**REZONING, PLANNED UNIT DEVELOPMENT
& SUBDIVISION STAFF REPORT****Date: January 8, 2009****DEVELOPMENT NAME**

Moran Investments, Inc.

Somerby Subdivision, Resubdivision of Lot 1

APPLICATION NUMBER 16,17,& 18 DATE January 8, 2009

SITE PLAN

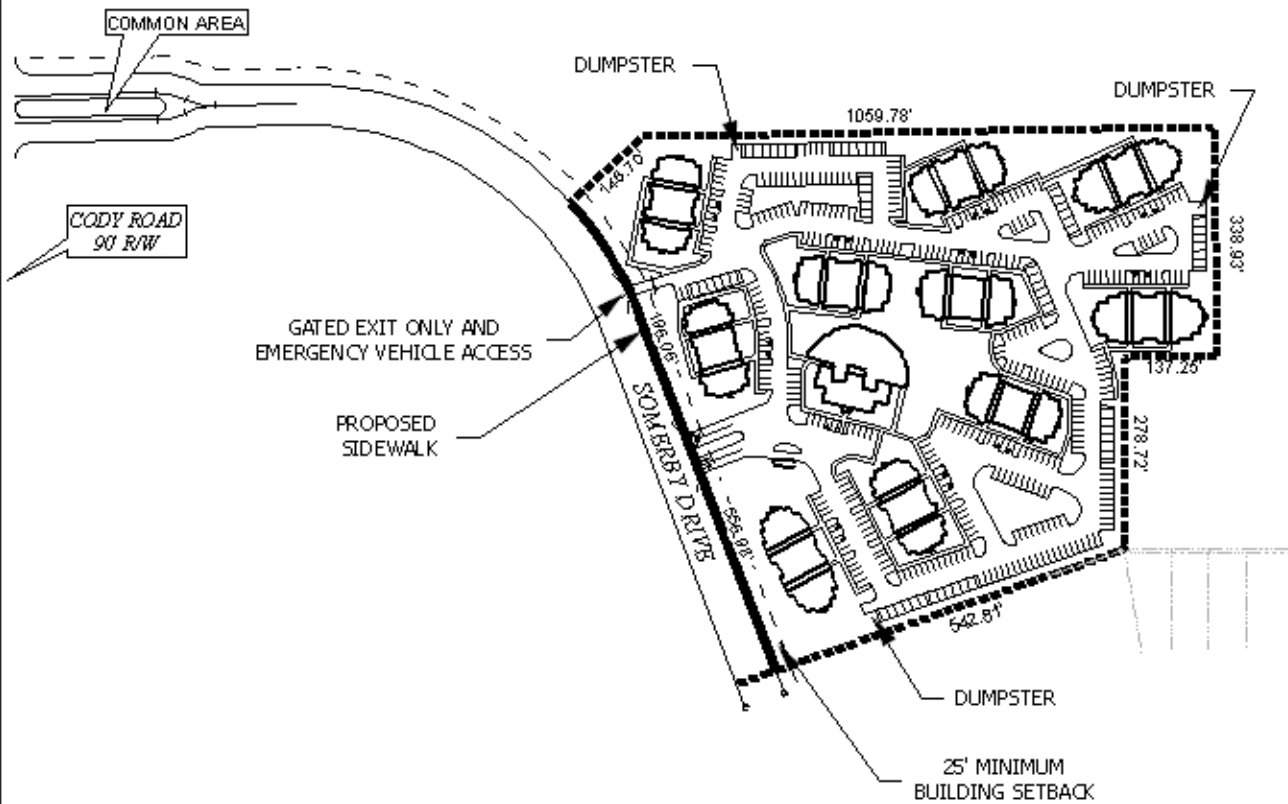
The site plan illustrates 10 apartment buildings (all 3 stories and ranging from 6,000 to 10,000 square feet) and a club house (4,135 square feet). For the 240 units proposed, 401 parking spaces are provided (only 360 are required), 60 of which are covered/garage parking spaces. While the site plan complies with the minimum landscaping requirements, there is no depiction of trees. The applicant should be aware that a Tree Plan, in compliance with Section 64-4.E.3 of the Zoning Ordinance, will be required at the time of permitting.

The applicant should revise the site plan to illustrate a buffer, in compliance with Section 64-4.D of the Zoning Ordinance, where the site abuts residentially zoned property. Furthermore, as required by Section 64-6.A.3.c of the Zoning Ordinance, any lighting for the parking lot shall be so arranged that the source of light does not shine directly into adjacent residential properties or into traffic.

Dumpster locations for the site are indicated on the site plan and in compliance with Section 64-4.D.9 of the Zoning Ordinance; however, the applicant should place a note on the site plan stating that dumpsters will be completely screened from view.

The applicant should also revise the site plan to provide a sidewalk along Somerby Drive.

- 1) placement of a note on the site plan stating that curb cuts for the site are limited to the approved Planned Unit Development site plan with the sizes, designs and locations to be approved by Traffic Engineering and in conformance with AASHTO standards;

- 2) provision of buffering, in compliance with Section 64-4.D of the Zoning Ordinance, where the site abuts residentially zoned property;
- 3) placement of a note on the site plan stating that lighting of parking facilities will comply with Section 64-6.A.3.c of the Zoning Ordinance;

- 4) placement of a note on the site plan stating that dumpsters will be completely screened from view;
- 5) provision of a sidewalk along Somerby Drive;

- 8) submission of a revised Planned Unit Development site plan to the Planning Section of Urban Development prior to the issuance of any permits or land disturbance activities;
- 9) provision of a Traffic Impact Study meeting ITE standards, to be reviewed and accepted by Urban Development Department and City of Mobile Traffic Engineering prior to signing the final subdivision plat; and
- 10) subject to City Engineering comments: *(Must comply with all storm water and flood control ordinances. Any work performed in the right of way will require a right of way permit. Must provide detention for any impervious area added since 1984 in excess of 4,000 square feet. Need to verify that there is sufficient capacity for the receiving drainage system to accept drainage from this property).*
